BLACKROCK ESTATES
SUBDIVISION OBSERVATION REPORT

July 25, 2012

HR GREEN JOB NO. 86120056

LOT 6

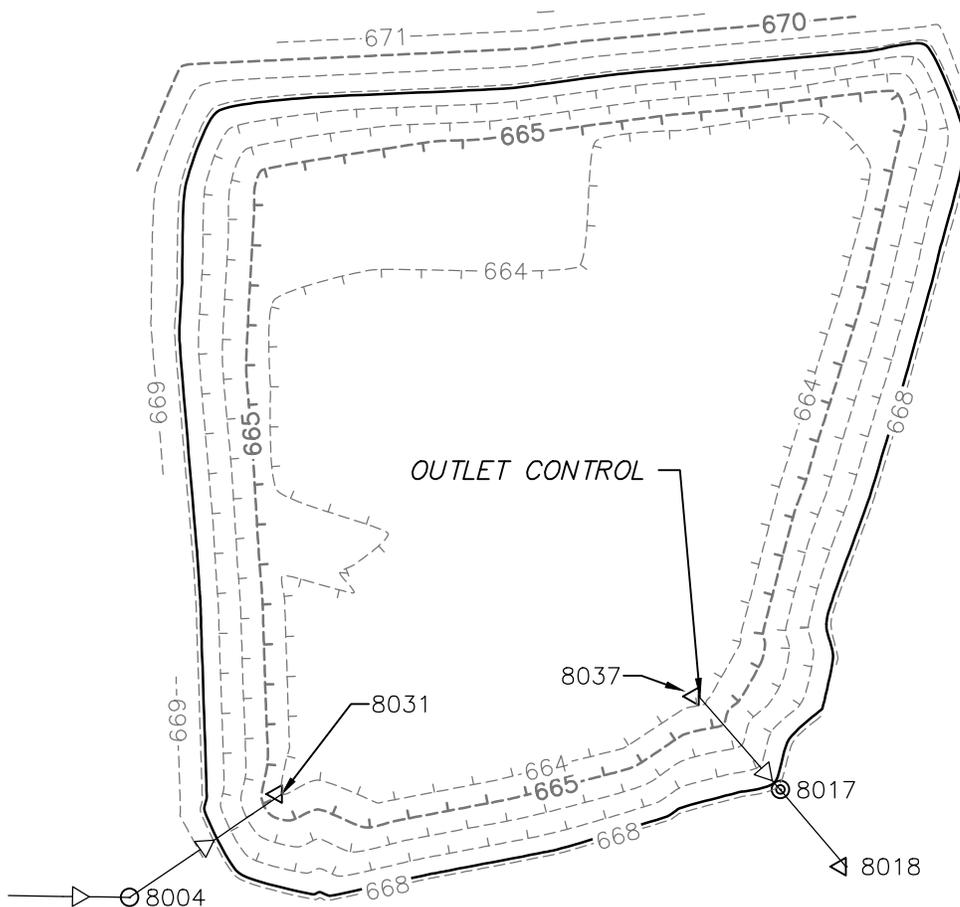
The weir wall and restrictor pipe were all constructed an average of 0.76' high. The resulting NWL and HWL elevations were also higher by a similar amount. The upstream impact of this increase could not be determined within the scope of our analysis. Our analysis does conclude that that existing pond does exceed the proposed and required storage volumes.
